SERVICE MEMO

Dispenser(s): *W100_Omni*
Title: Brewer Error / brewer difficult to mount

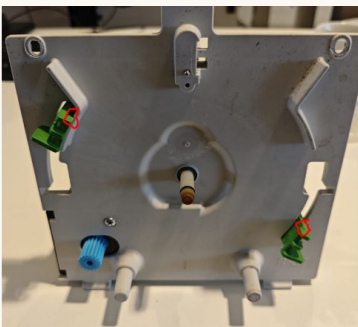
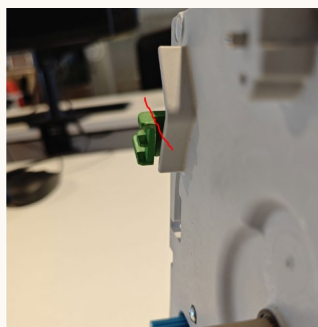
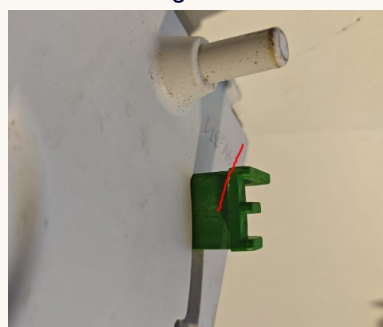
Reports are coming from the field that the brewer is not positioned correctly, the green lock on the left side is not positioned correctly and does not catch the brewer.

Make a finder at the point where the green handle touches the brewer. File a bevelled edge. Details see next page.
